Railway cutting adjacent to the existing Park Village East retaining wall - 2023/1268/HS2

Delegated Report		Analysis sheet		Expiry Date:	19/05/2023
(Members Briefing)		N/A / attached		Consultation Expiry Date:	07/06/2023
Officer			Application Number(s)		
Brendan Versluys			2023/1268/HS2		
Application Address			Drawing Numbers		
Railway cutting adjacent to the existing Park Village East retaining wall extending northwards from south of Mornington Street Bridge to northern extent of Euston Cavern Headhouse.			Please refer to draft decision notice		
PO 3/4	Area Team Signature	C&UD	Authorised Officer Signature		
Proposal(s)					
Amendment to scheme approved as part of Schedule 17 consent for the Park Village East Berm Wall (LPA ref: 2021/0126/HS2, dated 17/03/2021), comprising a retaining structure located in the railway cutting. CHANGES INCLUDE; to change the proposed replacement parapet wall with lower pre-cast L-shaped reinforced concrete wall panels; removal of the proposed upstand element, apart from adjacent to the Euston Cavern Shaft; change in colour to non-pigmented concrete.

Recommendation(s):		Grant consent			
Application Type:		Schedule 17 Application

Figure 2: Comparison of materiality between approved and amendment schemes.

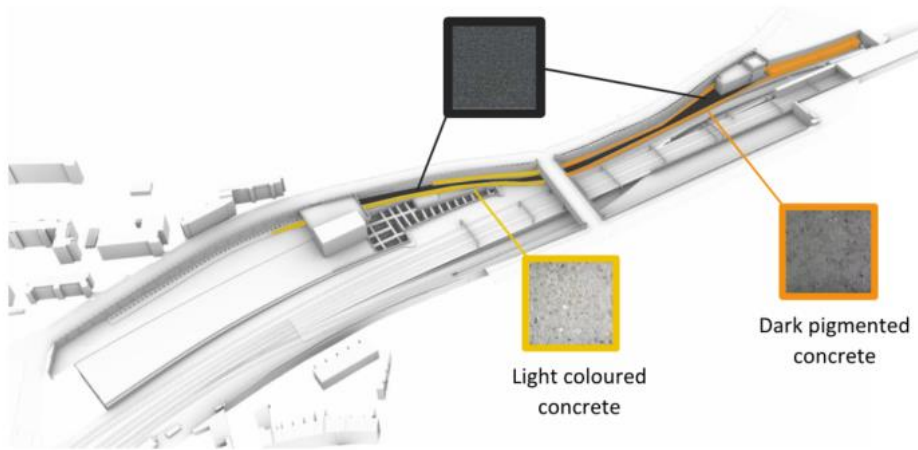
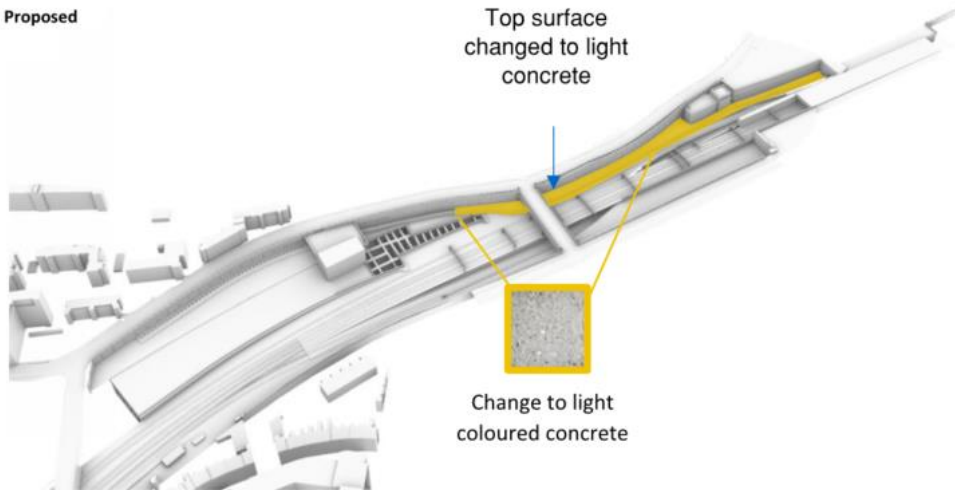
Asphalt to top

Top surface
changed to light
concrete

- Object to the change of colour proposed for the concrete of the proposed concrete wall panels. It was agreed by Camden in 2021 that the darker colour was appropriate to the historic character of the area: the basis of this judgment has not changed. Rather, as the Master Planning for the Over Site Development on behalf of LendLease has progressed, it is clear that the Cutting will become more visible than it is today. For example, plans for residential development within the existing cutting parallel to Mornington Terrace, with an open space, mean that the new work including that proposed in this application will be more visible as the setting of the Listed Buildings in Park Village East. The new work should be as consistent with the existing historic cutting as possible both in the present and for the future.

- 3.20 A number of objections relate to the proposed change in colour of berm support structure from 12% pigmented to non-pigmented concrete.
- 3.21 As discussed within the previous Schedule 17 application for the wall, the colour of the berm wall was of considerable discussion especially after a number of objections were received from neighbouring properties and amenity groups. HS2 have advised that previous visual examples indicate that the tone can be highly variable giving a “bleached” look to the surface. The proposed amended berm wall concrete finish, using a uniform mix of aggregate and cement, will minimise the variability in tone of the walls. The concrete finish will concur with the materiality of the berm, will naturally weather, and darken as it picks up atmospheric pollution, consequently the appearance will change over time and generally accord with the other assets within the cutting.

Figure 3: Comparison between approved and amendment schemes showing removal of upstand element

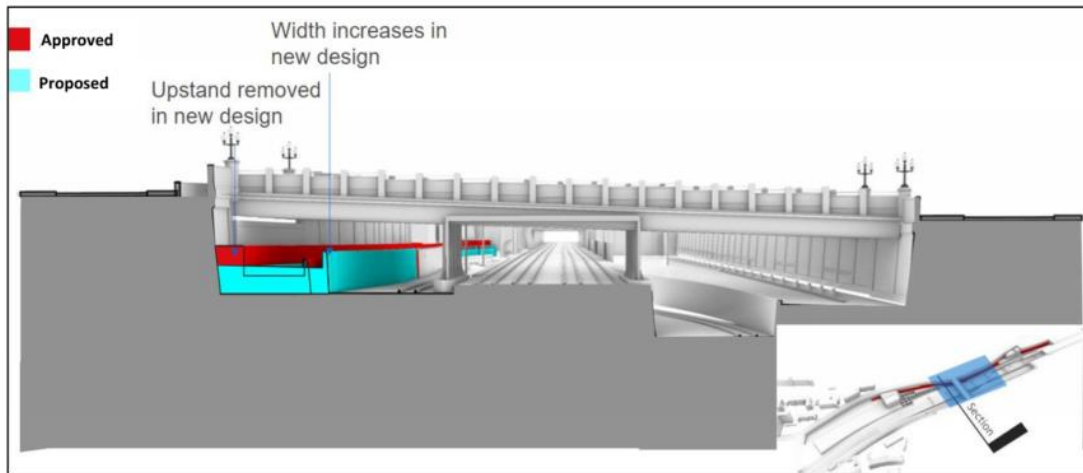
- Replacement of parapet wall with lower pre-cast L-shaped reinforced concrete wall panels;
- Removal of the significant upstand element, apart from to the rear of the Euston Cavern Shaft where it will be concealed from view;
- Change in colour of berm support structure from 12% pigmented to non-pigmented concrete.
